Intersection ID: 14901	Main Street: BALTIMORE_AV	Cross Street: FAIRWOOD_AV	Location:	NW
ADA ID: 2E6EAAF87434	Ramp Type: PerpDiag	Initial Pass/Fail: Fail	Overall Compliance: No	Severity Score: 37.5

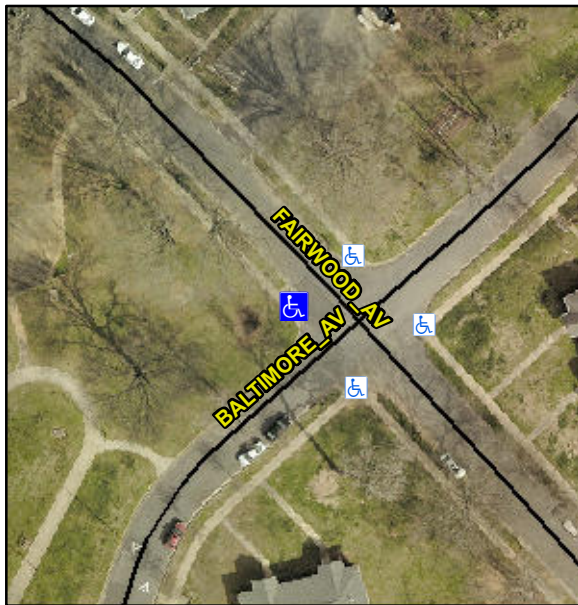
**Not Found, R304.2.2, R304.5.3**

Compliance	Description	Data	Compliance	Description	Data
N/A	Ramp Length (in)	48.0	No	Ramp Slope (%)	8.4
Yes	Ramp Width (in)	48.0	No	Ramp XSlope (%)	7.4
N/A	Flare Type LT	N/A	N/A	Flare Type RT	N/A
N/A	Flare Slope LT (%)	N/A	N/A	Flare Slope RT (%)	N/A
N/A	Flare Traversable LT?	N/A	N/A	Flare Traversable RT?	N/A
N/A	Landing Length (in)	N/A	N/A	DWS Provided?	N/A
N/A	Landing Width (in)	N/A	N/A	DWS Contrast?	N/A
N/A	Landing Slope (%)	N/A	N/A	DWS Length (in)	N/A
N/A	Landing X Slope (%)	N/A	N/A	DWS Full Width?	N/A
N/A	Landing Curb? (Y/N)	N/A	N/A	DWS Offset (in)	N/A
N/A	Shared Landing?	N/A			
N/A	Gutter Ponding?	N/A	N/A	Gutter Slope (%)	N/A
N/A	Gutter Lip Ht (in)	N/A	N/A	Gutter X Slope (%)	N/A
N/A	Painted X Walk1?	No	N/A	Painted X Walk2?	No
	X Walk 1 Direction	To NE		X Walk 2 Direction	To SE
N/A	X Walk 1 Width (in)	N/A	N/A	X Walk 2 Width (in)	N/A
	X Walk 1 Slope (%)	5.5		X Walk 2 Slope (%)	1.1
	X Walk 1 X Slope (%)	0.7		X Walk 2 X Slope (%)	3.4

**Remove & Replace Curb Ramp With Two New Directional Ramps or Equivalent.**
